Access Compliance Report

Public Rights-of-Way

| Intersection ID: 48092 | Main Street: HOLLAND_AV | Cross Street: STATESVILLE_AV | Location: SE |
| ADA ID: 257A6166A9EE | Ramp Type: PerpDiag | Initial Pass/Fail: Fail | Overall Compliance: No |

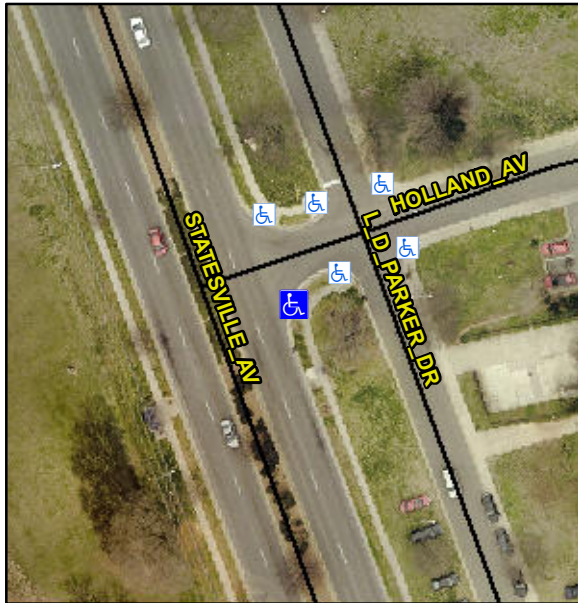
R304.5.1, R304.2.2, R304.5.3

| Compliance | Description | Data | Compliance | Description | Data |
|------------|-----------------------|------|------------|-----------------------------|------|
| N/A | Ramp Length (in) | 61.5 | No | Ramp Slope (%) | 8.4 |
| No | Ramp Width (in) | 38.0 | No | Ramp XSlope (%) | 5.0 |

Remove & Replace Curb Ramp With Two New Directional Ramps or Equivalent.
